From: Aberson, Marja
Sent: 07 March 2019 20:37
To: McGlynn, Stephanie
Cc: Kiernan, Sarah; Wilson, Rachel
Subject: RE: GDD - Shellfish Summary
Attachments: Lit review - e coli.docx

FCC are a local authority in which the Greater Dublin Drainage Project will be located.

As discussed, the area we are hoping to discuss and understand further is how the shellfish (Razorclam, crab and lobster primarily) deal with E coli present in the water.

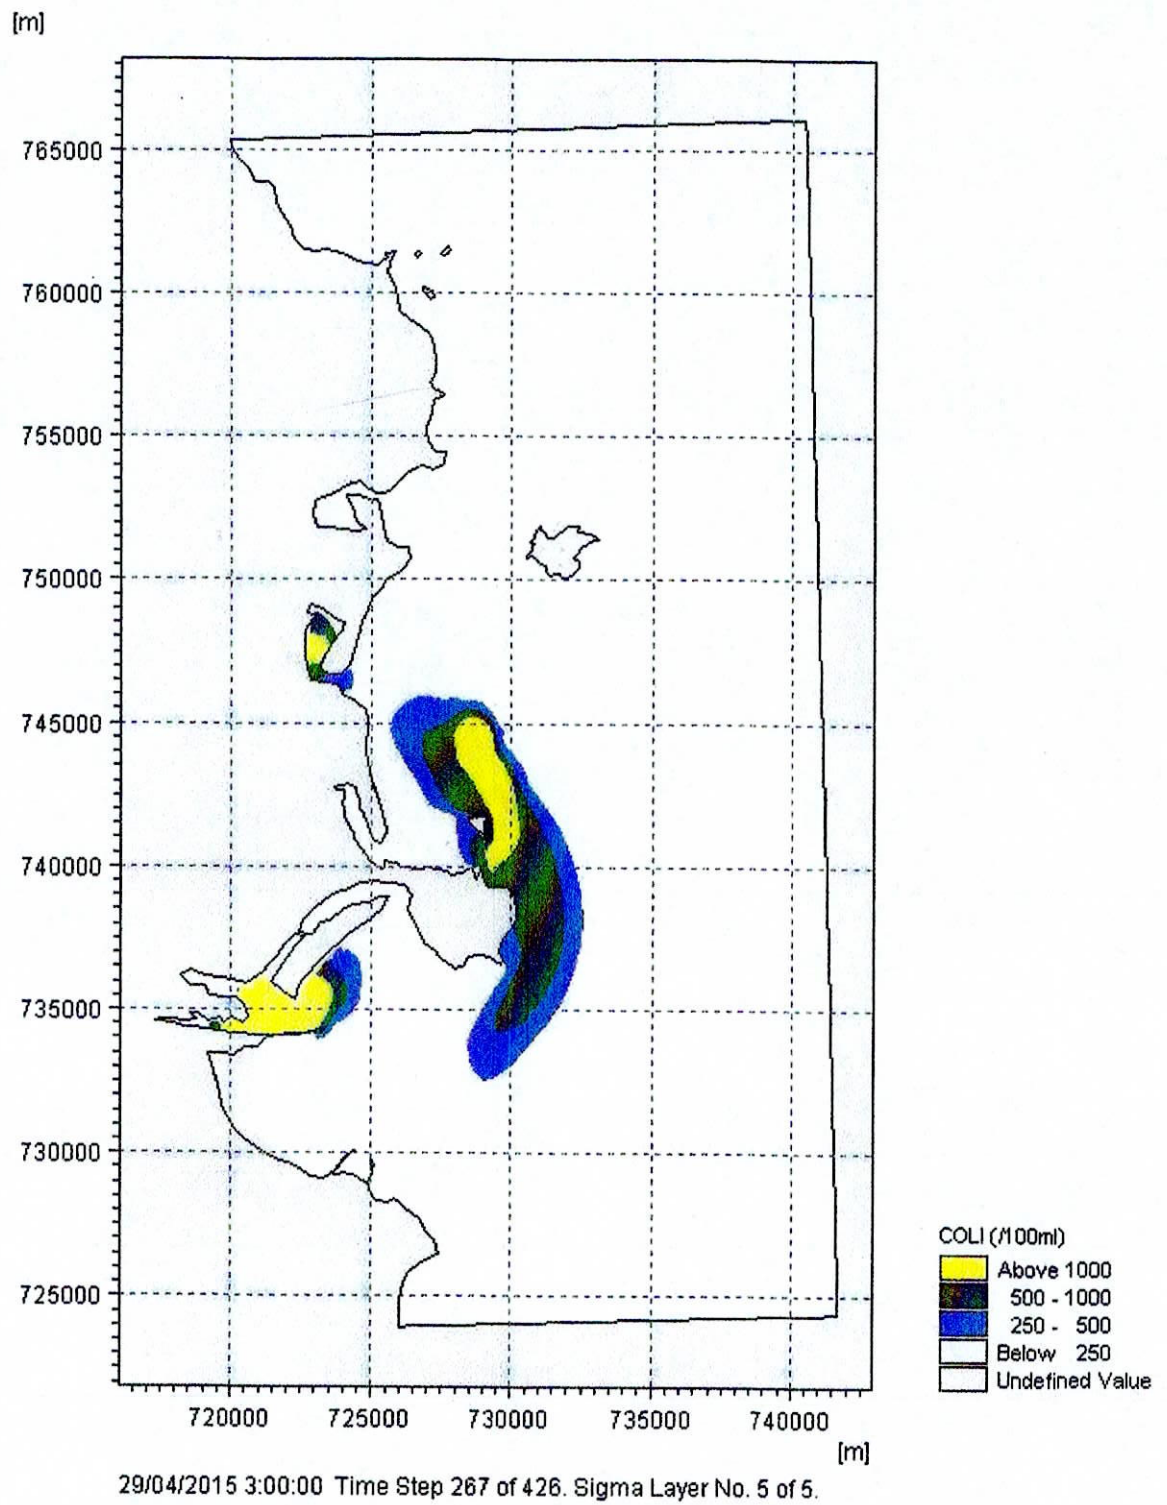
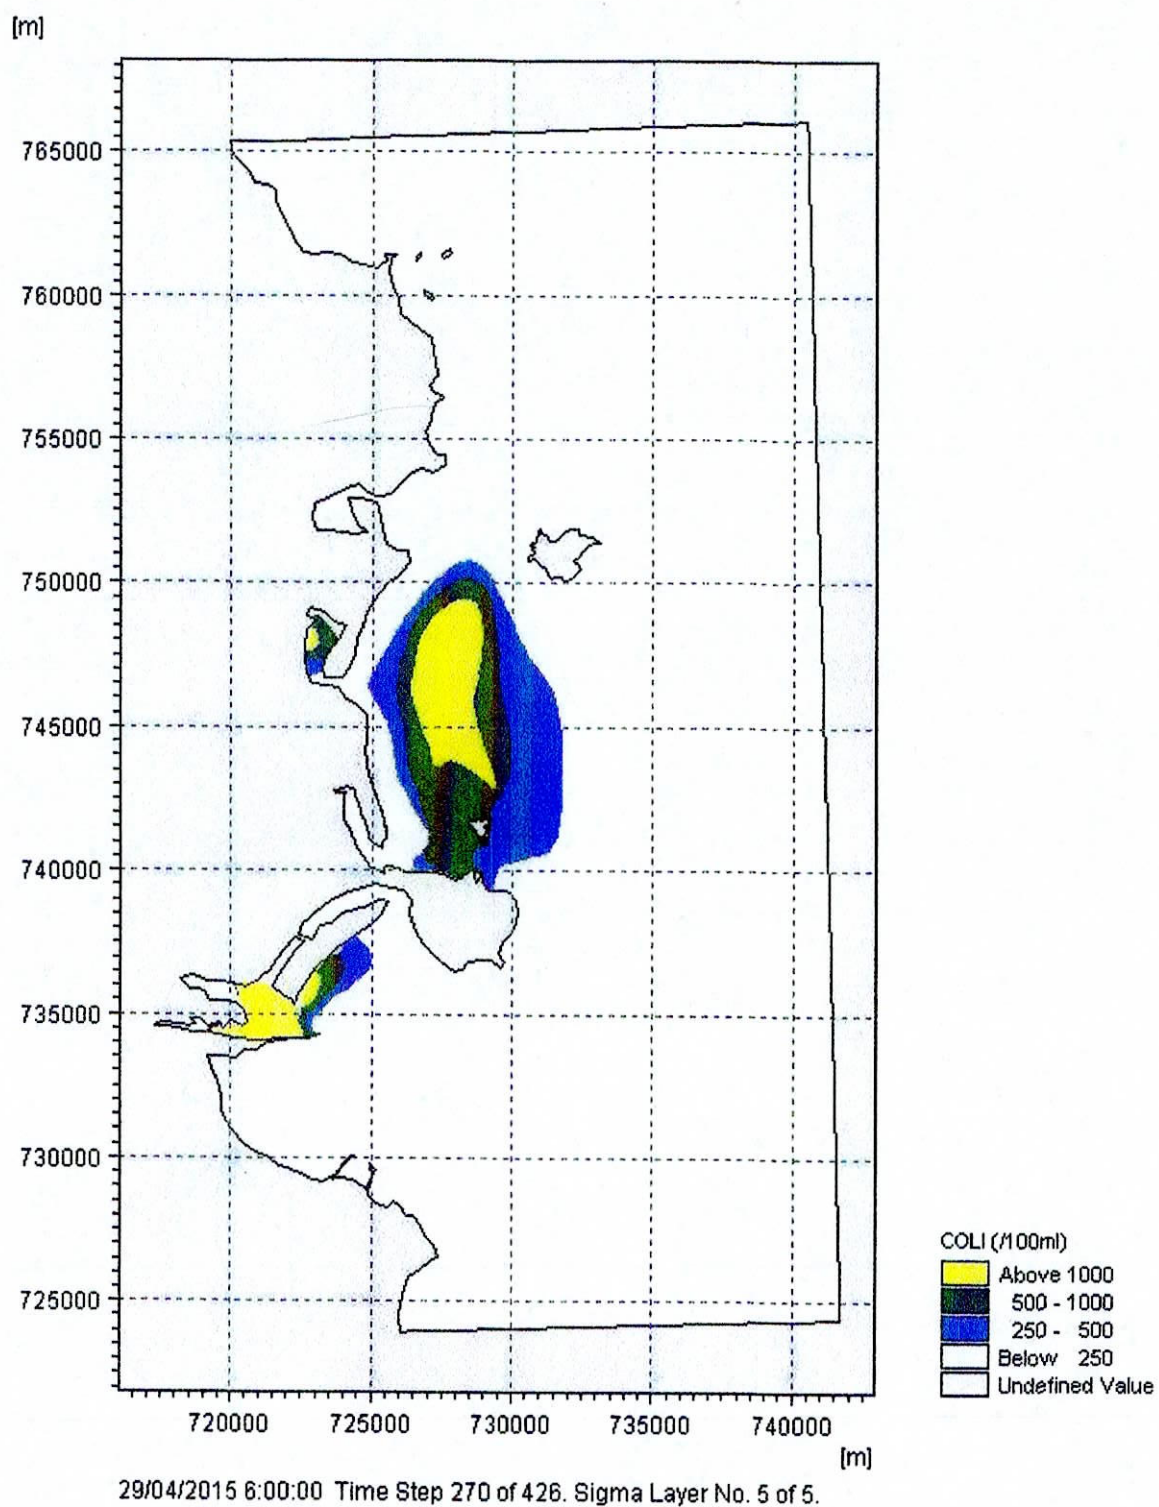
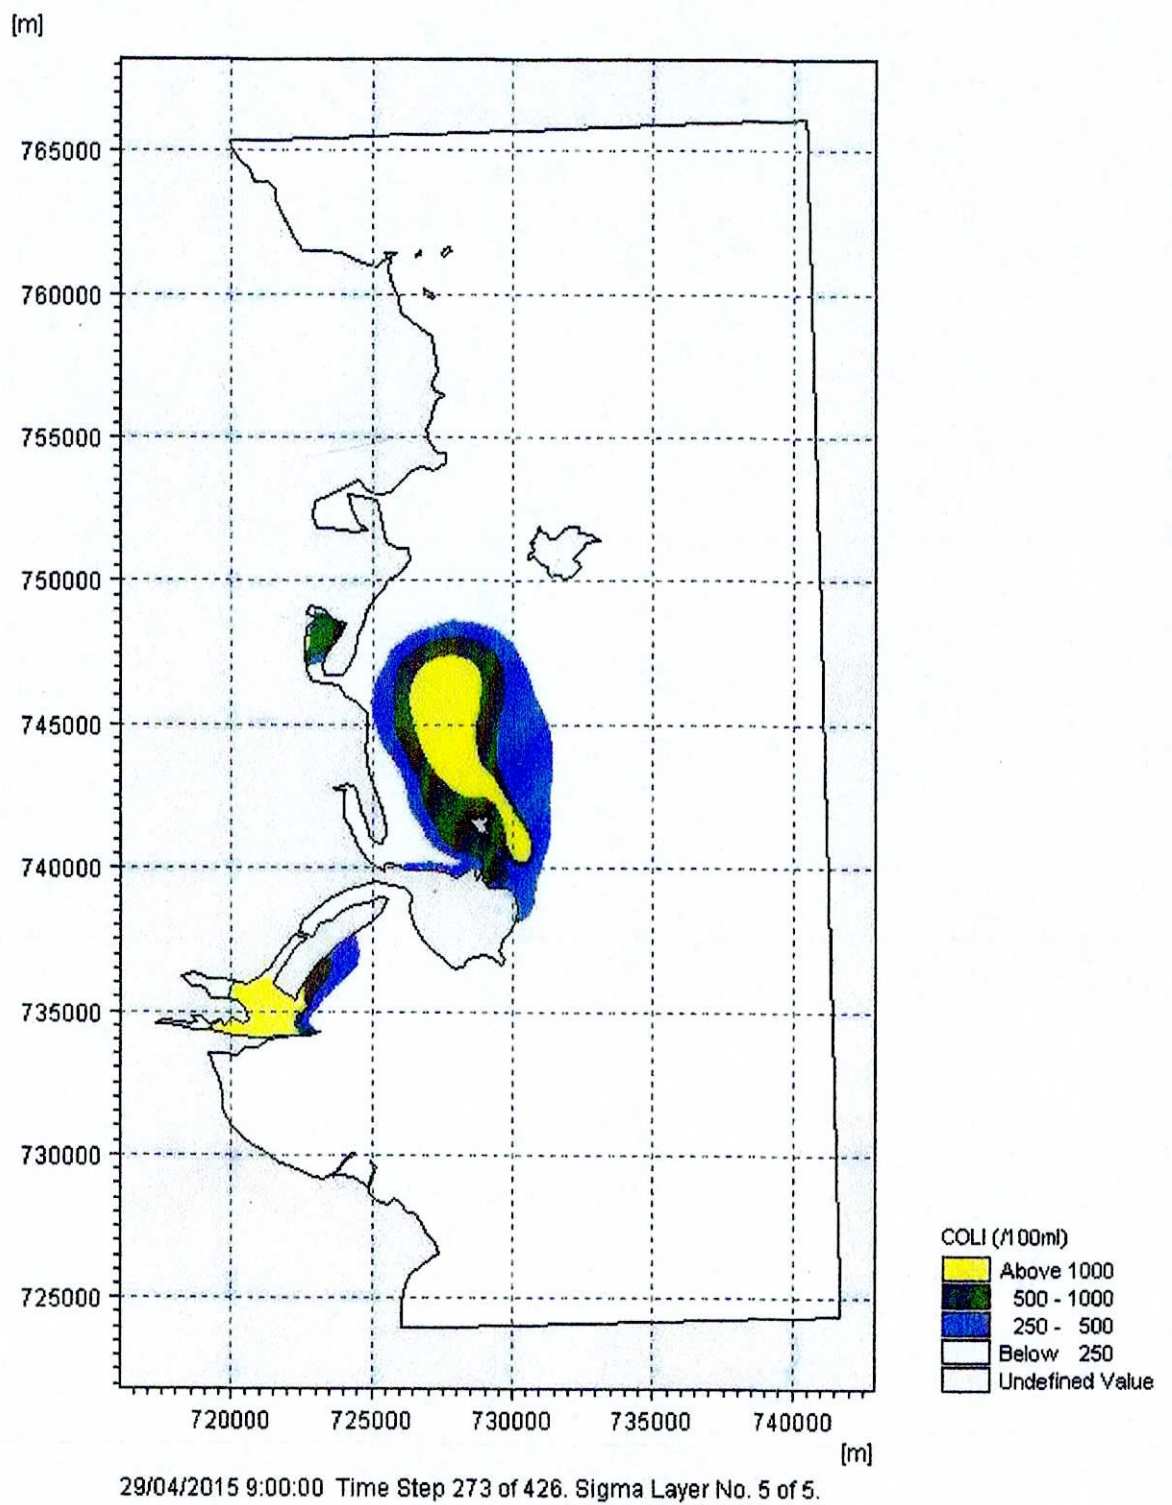
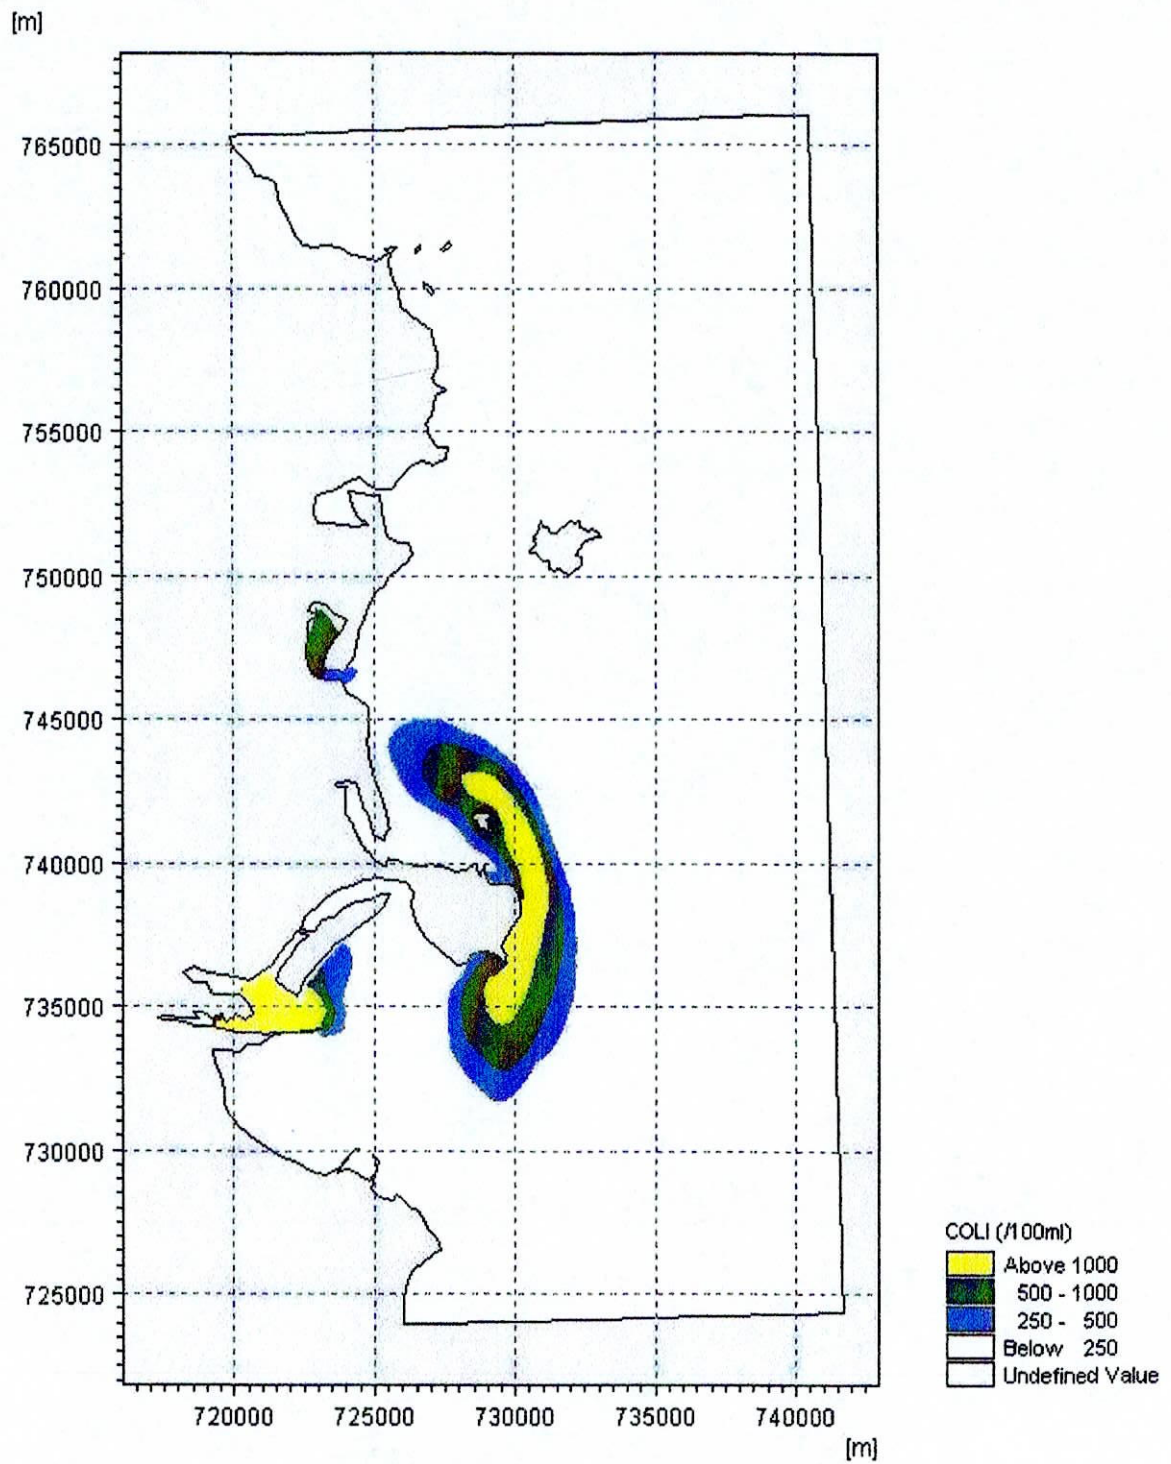
Questions: - multiport OR Single diffuser USED IN MODEL?

- why not model each day? why final day

- what happens if process failure in Ringsend + GDDP? which includes All SWO CSO overflow/discharge.
